# SS 3090 FTL2021 M2-106 DD8 Engine Harness Chafing Air Compressor Suction Line

FTL M2 106 with DD8 Engines.

Figure 2: Revised Engine Harness routing adding additional clipping point.

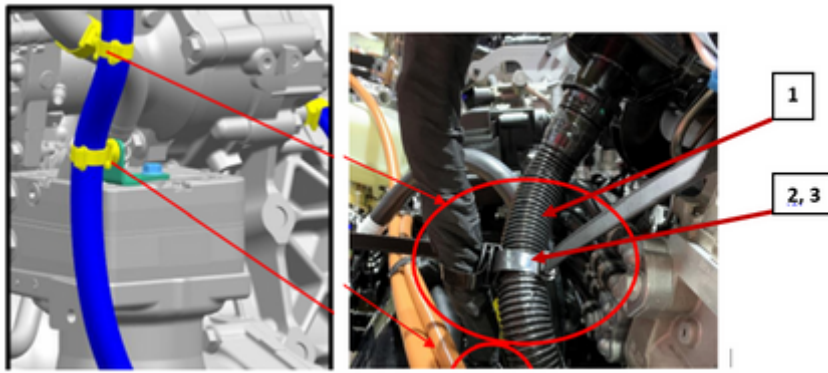
Engine Harness routing may cause chaffing/rubbing with Air Compressor suction line creating air leaks that in some cases may not allow the system to build air pressure. A hole in the suction line allows dirty air /debris to be sucked by air compressor with potential to damage internal components of the air compressor.

Engine Harness routing needs to be revised adding a Mounting-Tie, Cable, Dual Swivel and two Clamp Cable Ties to bundle Harness and suction line together as shown in the Figure 2.

1. Park the vehicle, shut down the engine, and apply the parking brakes. Chock the tires.
2. Disconnect the batteries.
3. Open the hood to get access to the Air Compressor Suction Line and Engine Harness.
4. Remove and replace Air Compressor Suction Line with new Suction Line Item 1.
5. Install Items 2 and 3 to bundle together Harness and Suction Line. Care must be taken to avoid crushing the Suction Line and causing air intake restrictions.
